# Land-Rover Service Newsletter Vol. 3 No. 9

December 1969

The Rover Company Limited Service Department: Solihull, Warwickshire, England

**Radiator filler cap identification**

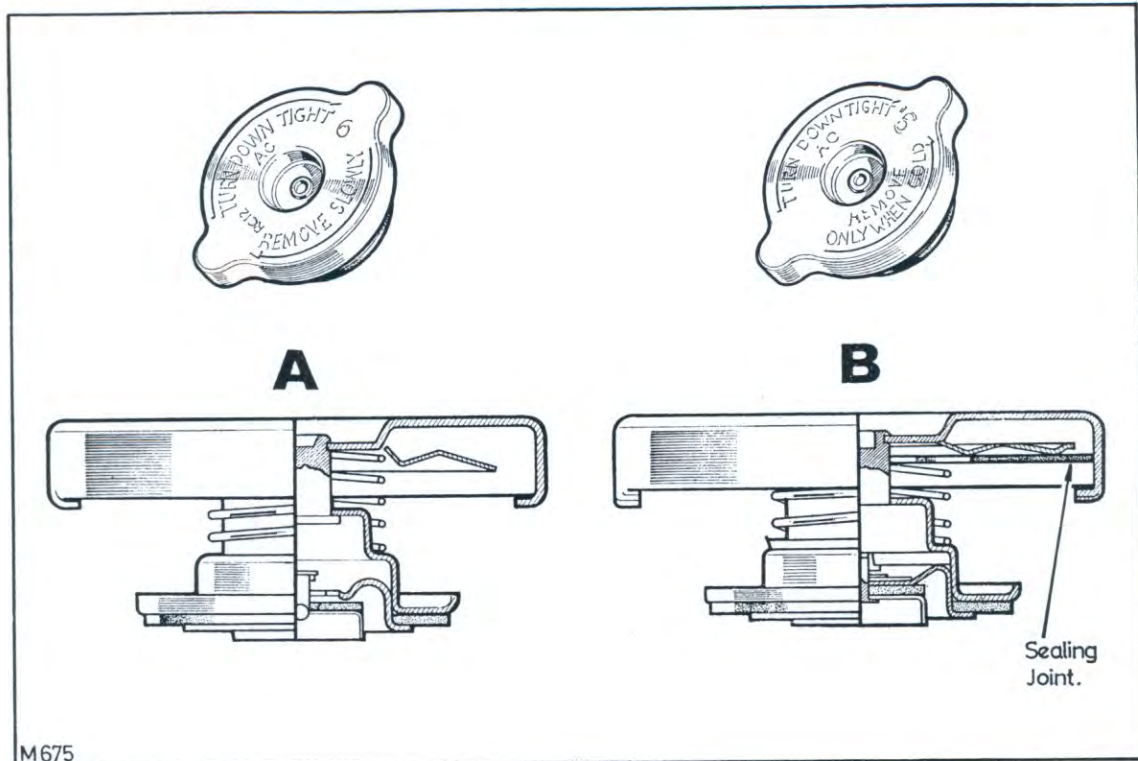
REMARKS: Radiator filler cap, Part No. 564713 has been used since the introduction of the semi-sealed cooling system with the overflow bottle. It contains a sealing joint, which prevents air entering the radiator during the cooling off period.

It has been brought to our notice that lost or stolen radiator caps are sometimes being replaced by the earlier type cap, Part No. 509767, which does not comprise a sealing joint. The use of this cap renders the overflow system ineffective by admitting air into the system during the cooling off period, and thus preventing the coolant trapped in the overflow bottle returning to the header tank. Deprived of the correct quantity of coolant in the system, the engine may overheat and could suffer serious damage.

A—Old type filler cap, Part No. 509767    B—Current type filler cap, Part No. 564713

In order to eliminate this danger, radiator filler cap, Part No. 564713 will be supplied for all Service replacements, when stocks of Part No. 509767 are exhausted.
